CJ Industries Limited’s resource consent applications at 134 Peach Island Road, Motueka for gravel extraction with vehicle access via a right of way over 493 Motueka River West Bank Road, Crown land and unformed legal road - Council reference RM200488 and ors

Report to	Commissioner (Resource Consent) Hearing
Meeting date	21 November 2022, 22 November 2022, 24 November 2022 (& 25 November 2022 reserve day)
Report author	Alastair Jewell, Principal Planner - Resource Consents
Report number	REPC22-11-21A
Attachments:	<ol style="list-style-type: none"> 1. Section 42A report and recommendation (Addendum) by reporting planner 2. Recommended draft conditions RM200488, RM200489, RM220578 3. Supplementary technical review – noise assessment – Daniel Winter 4. Supplementary technical review – dust assessment – Leif Pigott 5. Supplementary technical review – traffic effects assessment – Ari Fon 6. Supplementary technical review – land production values – Mirka Langford

The Addendum to the existing Section 42A report and recommendation on the resource consent application (Attachment 1) has been prepared by Susanne B Solly as the Council’s consultant reporting planner.

Figure 1: Location of proposed noise bund (blue line) screening 131 Peach Island Road

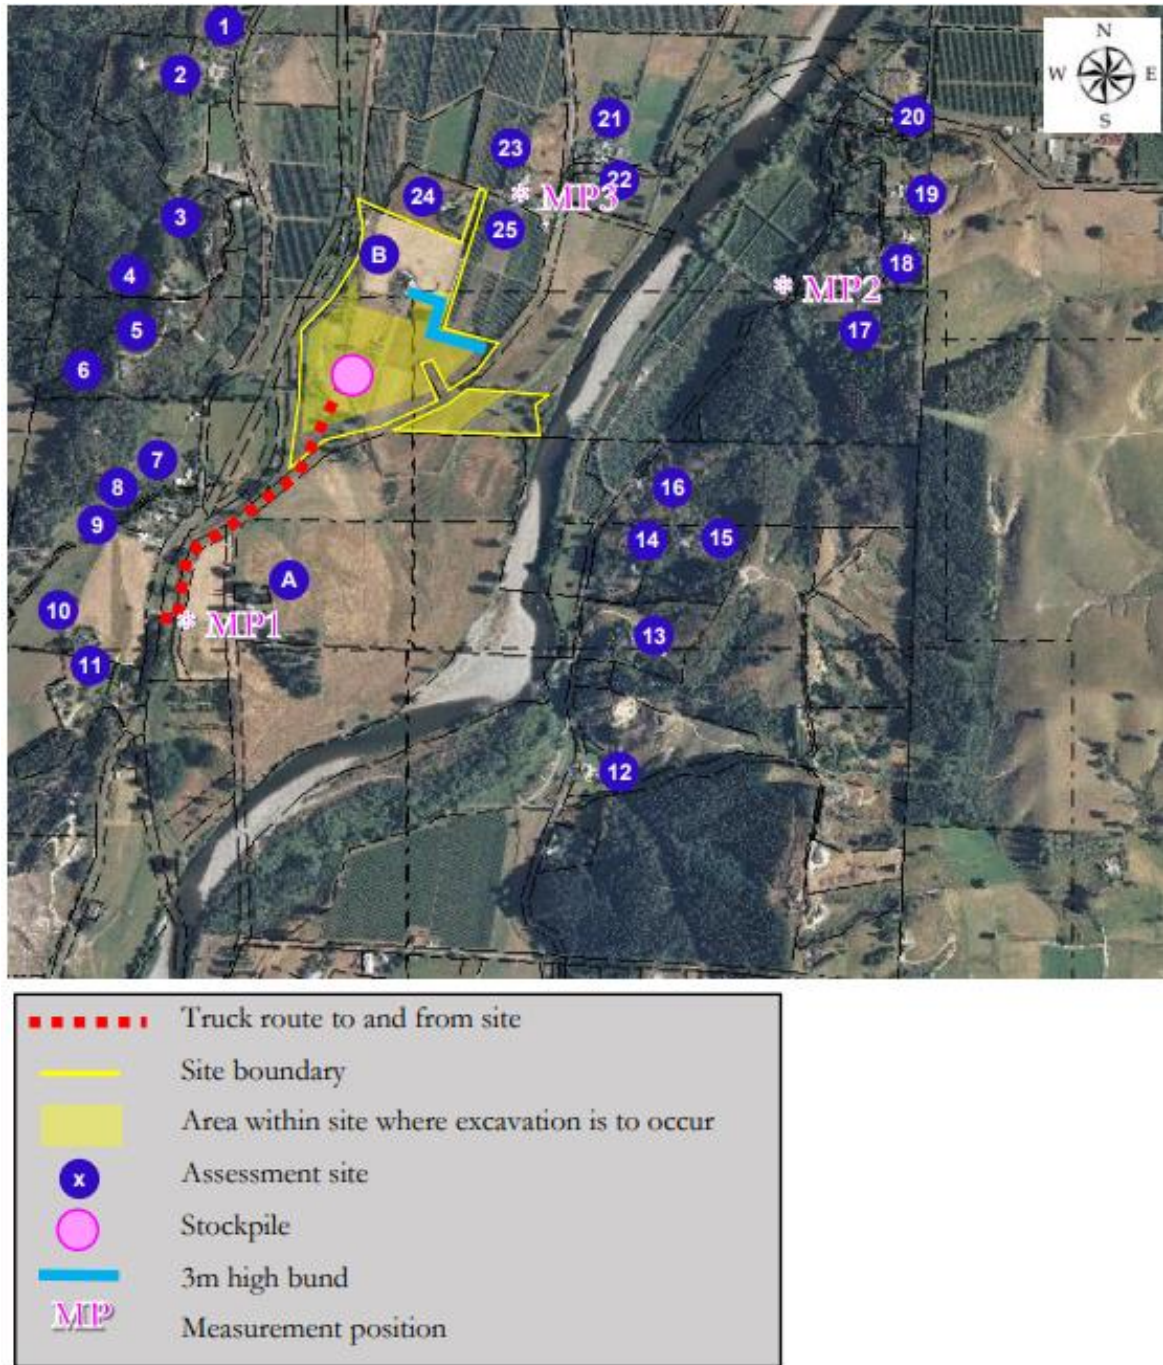
- 5.3 In addition to the mitigation measures detailed in the 2021 Hegley Noise Management Plan, it is now proposed to construct a 3 m high bund in the location shown on Figure 1 to acoustically screen 131 Peach Island Road. Mr Winter agrees with the proposed mitigation. I support this position.

Figure 2: Ownership of land adjacent to the haul road

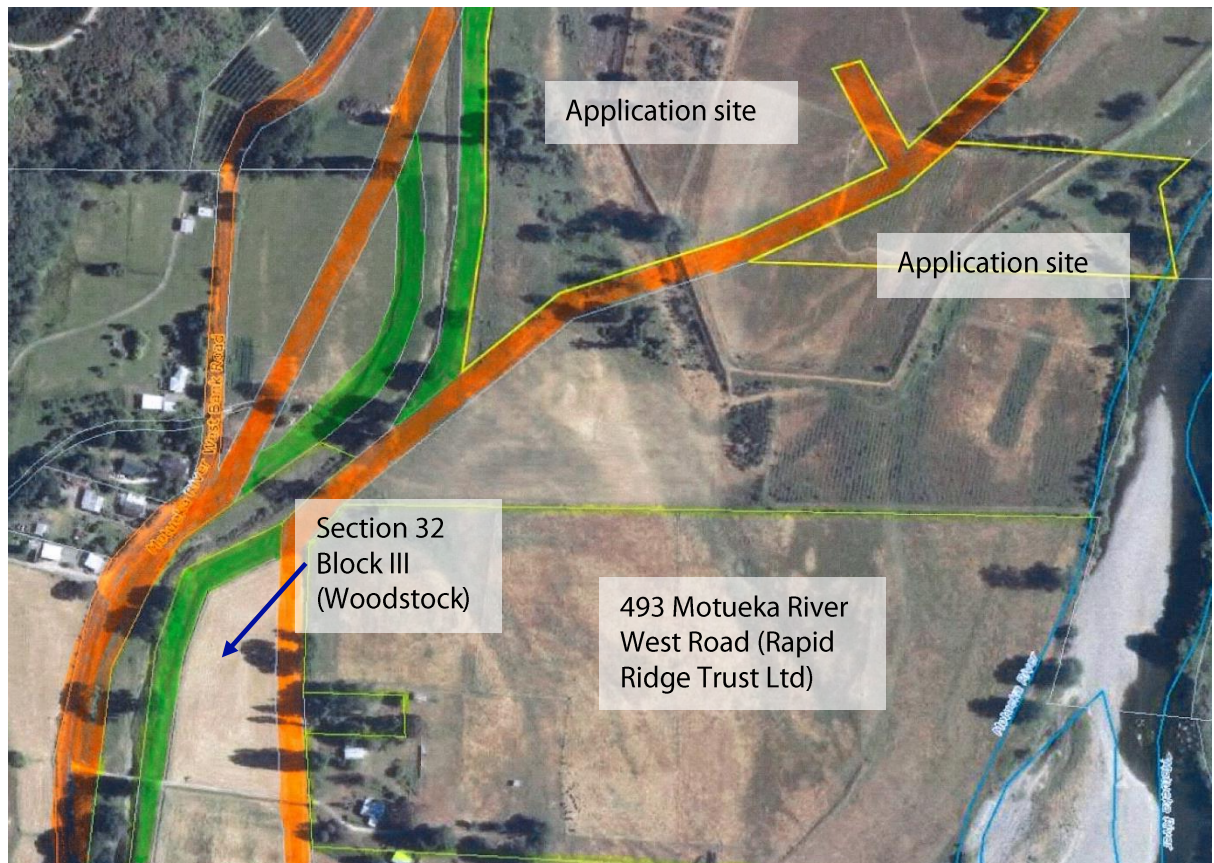
- 6.13 This was detailed in the s 42A report; however, the parcel labels (A, B, C) appear to have been omitted. I have therefore included Figure 2 again. For sake of clarity, parcel “A” is part of 493 Motueka River West Road; the parcels labelled “B” are owned by A E & D L Woodcock; and the parcels labelled “C” are owned by C G, C M and G H Le Frantz (submitter #37).

- 6.14 Given that the proposed access includes other / existing ROW users and third party contractors, and potentially public access (refer to Sections 5.37 and 5.38), I concur with Mr Fon that this initial section of the access up to the bridge needs to be formed to a width of 6 m to allow trucks to pass each other. I have recommended a condition to this effect to ensure there will be no impediment to trucks turning off Motueka River West Bank Road into the access.

"When combining the influences of the scale of the activity, the sensitivity of the receiving environment, the proposed mitigation measures and dust travel distance, I consider the potential effects of dust discharged from the proposed activity are less than minor."

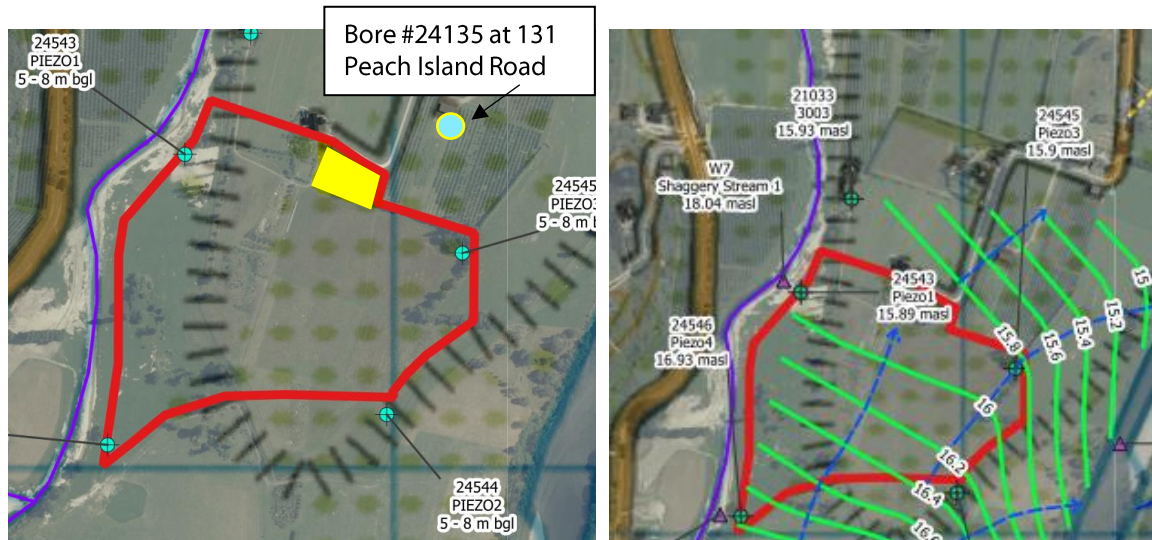
7.29 In order to establish background water quality, the applicant proposes to take two samples (from one upstream and two downstream dedicated monitoring bores), 3 months apart, prior to works commencing. The location of the dedicated monitoring bores is shown in Figure 1 of the GMP. Dr Rutter states: *"I do not consider two samples to be sufficient to characterise background quality."* The Council's Senior Resource Scientist, Joseph Thomas, previously advised that a minimum of three samples (at least two weeks apart) need to be taken prior to commencement of any works to establish background levels.

7.30 The three onsite dedicated monitoring bores will be sampled 3-monthly for the duration of the consent and sampling will continue until two years after quarrying and backfill activities cease. The applicant’s further information response received 2 September 2022 states that the two downgradient monitoring bores are located closer to the quarry boundary than downgradient bores used for drinking water supply. However, given the indicative ground water flow direction, it appears that when quarrying the northernmost area of Stage 2 (shaded yellow below), the closest downgradient bore would be at 131 Peach Island Road.
